ADDENDUM 4

ITB AP 59-20

CONSTRUCT BAGGAGE HANDLING SYSTEM AND WEST TERMINAL EXPANSION – DESTIN-FORT WALTON BEACH AIRPORT (VPS)

GSP No: 17182.03
File:
Scale:
Drawn By:
Checked By:
Sheet: M0.1
Date: AUGUST 5, 2003

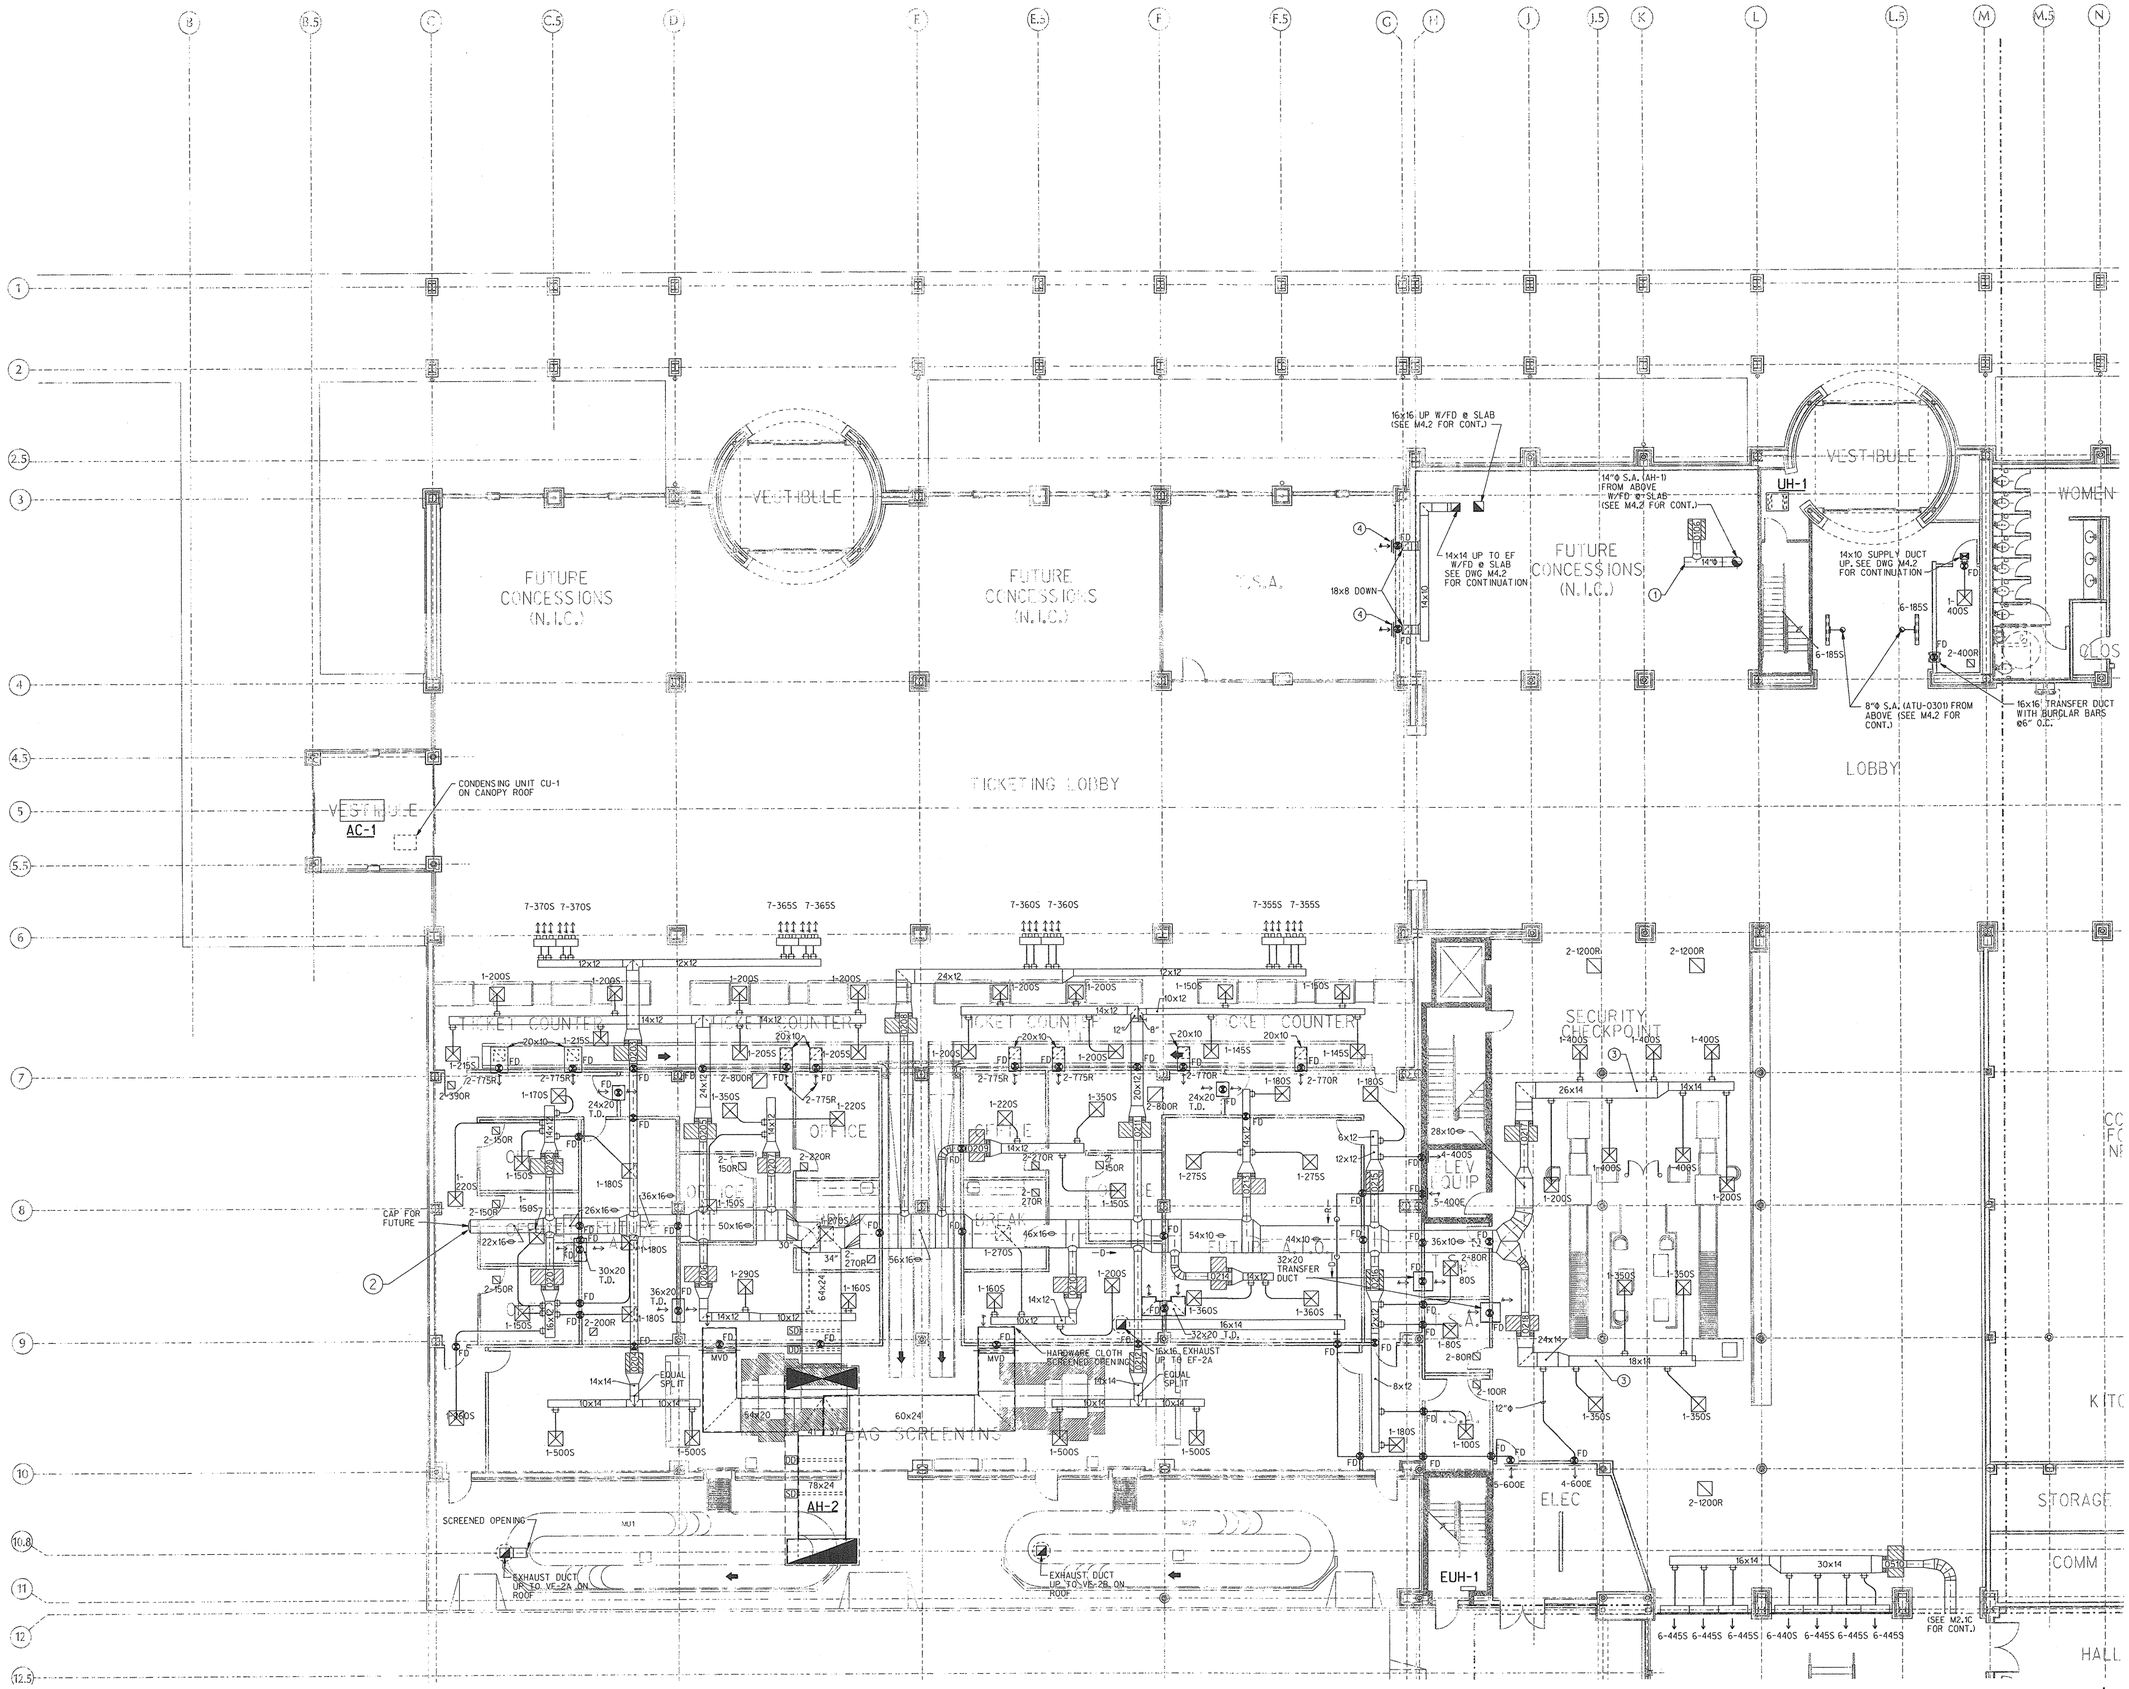
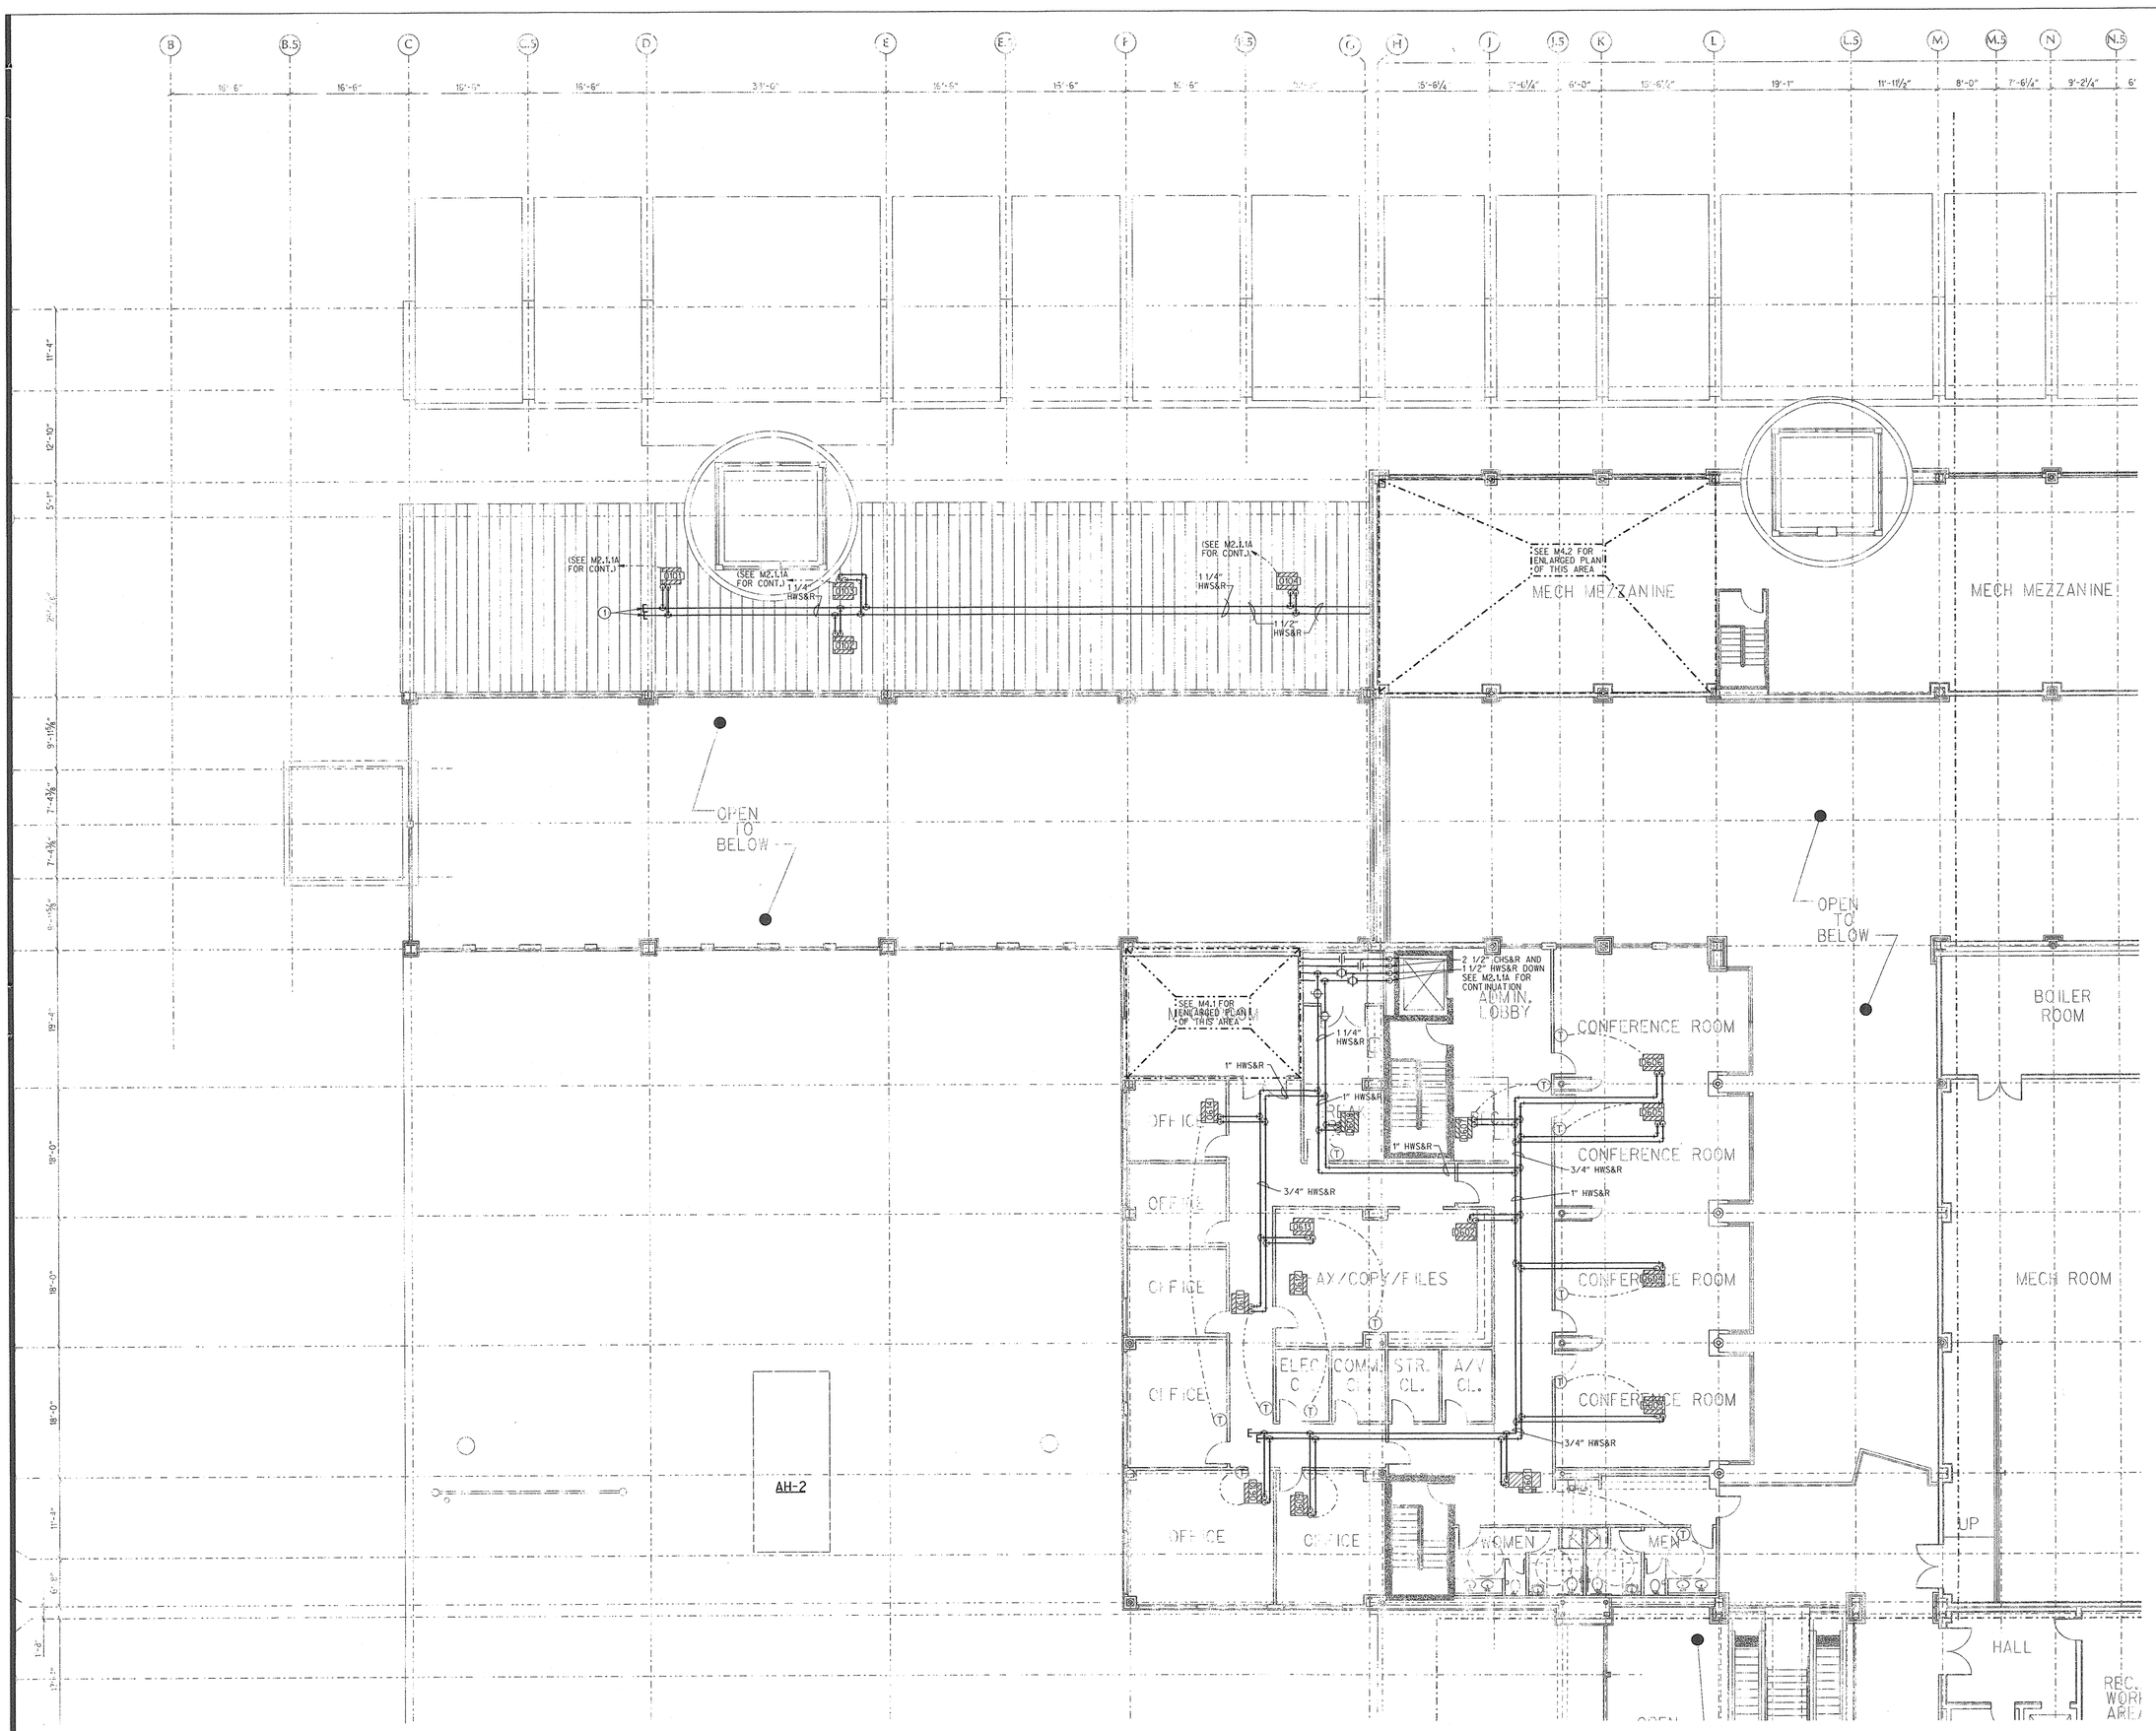
83. Can more information be provided regarding existing AHU-2?
Answer: See AH-2 on existing drawing excerpts dated 8/5/03 attached (M0.1, M2.1A, M2.1.1A, M2.2.1A)
